RE: Seattle Asian Art Museum in Volunteer Park

FSOP-Landmarks Board – Seattle Asian Art Museum in Volunteer Park - Comments

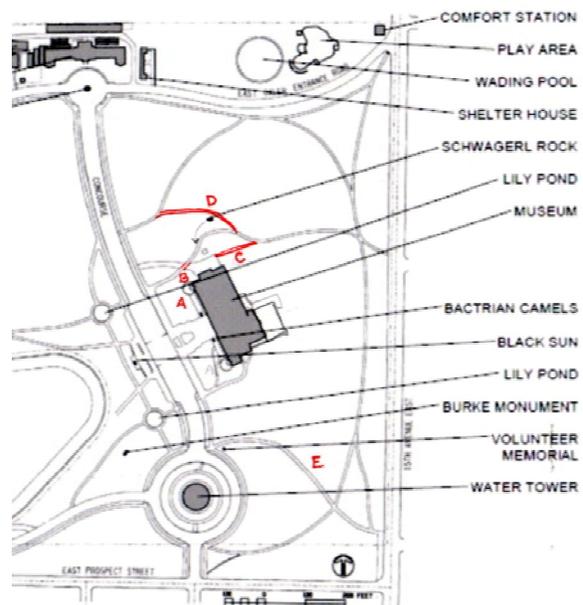
In commenting on the current proposal, the proposed interface of the building expansion to the east with the ground plane is of particular concern. There is an opportunity to reduce the scale of the building by setting it into the existing grade. Identifying a suitable interface of the building with the park needs to be defined from the perspective of how the building resides within the site. The landscape as described in the 1903 Olmsted Brothers report was to be of a “neat and smooth style of landscape gardening throughout, thus harmonizing with its surroundings.”

The museum proposal to further extend its footprint into the park by grading a terrace extension 20-26 feet eastward from the proposed 35-foot addition is contrary to preserving the park landscape. It creates a totally new landscape that is not compatible with the historic character of the east side of the park as a greensward with a gently sloping lawn interspersed with trees and planting. The museum needs an egress door on the lower level, but it does not need a terrace or a floor-to-ceiling bank of windows. Having entertained a range of aspirations for what the addition might provide, we now more clearly recognize that the east side of the building sits in an informal natural landscape compared to the formal character of the highly designed west entry. Therefore, we find programmed space added to the backside of the building to be inconsistent with the historic site. Rather, there should be a more focused examination of the building placement within the existing landscape and how it serves as a backdrop for the park in the least intrusive manner.

As such, the transition to the greensward should begin immediately at the eastern edge of the museum building.

The proposed new addition to the south and east façades is generally an unbroken mass, that will loom over the park. Identifying ways to modulate this scale would be very beneficial in reducing the impact on the park. Since the SE corner of the expansion is the tallest point from the existing grade and, as currently designed, is topped with a large mass without relief of fenestration, providing for planting to screen the building along the south and east would be beneficial.

– Current park plan

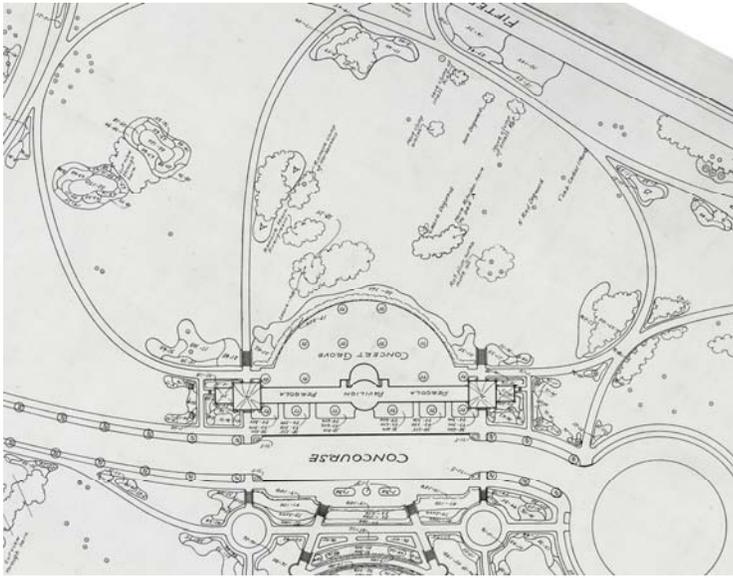
- A. In the lawn in the front (west side) of the museum, the landscape architect proposes to install a new ADA path through the north Hoggson lawn and to reconfigure the existing one in the south lawn to be compliant. We support making the south path compliant, but do not think that inserting a path in the north lawn is appropriate, since it was not part of the Hoggson plan. Inserting intrusions just for the sake of creating symmetry does not meet the intent of Federal Standards. The path on the south side requires less grade change and thus can sit more discreetly in the landscape.

- B. The existing path that connects the north lawn of the museum to the northeast park greensward, is an important connector within the park and provides a typical Olmstedian experience of transitioning between spaces and being able to see through and be drawn to the next space. The upper section of this path is part of the Hoggson plan, which reconnected the original east-west Olmsted path when the museum was built in 1932.

The museum proposal takes over this path as access to the elevated ADA ramp for staff. We believe that both needs can be met, by having the path divide to join the ramp and allow the park path to continue down into the park. Retaining this path is highly desirable.

- C. Reestablishing the east-west Olmsted path is important for continuing access from the east side of the park to the heart of the park in front of the museum. The Hoggson plan was laid out to retain this important east-west connection, but over the years it has, in effect, been blocked by parking and dumpsters.

There is an opportunity to reinstate this historic connection, not as a main ADA path, but as an optional path connection so that park users have a convenient and direct way to get from the east side of the park to the front of the museum. The dumpsters are proposed to be placed out-of-sight behind the loading dock and there is no need for a parking lot to

take up park land when there is plenty of parking elsewhere and nearby in the park. With the reconfigured loading dock area, the path can share the driveway which will have relatively limited use on any given day. Since it won't be a main path it can easily be blocked off when special events are happening that would require exclusive museum use.

- D. The proposed ADA connection north of the museum in the northeast greensward by itself takes park users far out of their way, but in combination with the existing and reinstated path connections described above (B. and C.), it could potentially provide an acceptable ADA route if the grading and landscape impacts are properly addressed in laying out the path. Further analysis of circulation routes in the park needs to be done before implementing this new path connection (see E. below).
- E. Resolving ADA access from the SE corner of the park, where the bus stops are that serve the park and museum, needs more attention. Improving such access and determining how it should go through the park is a critical need in addressing pedestrian and wheelchair access.
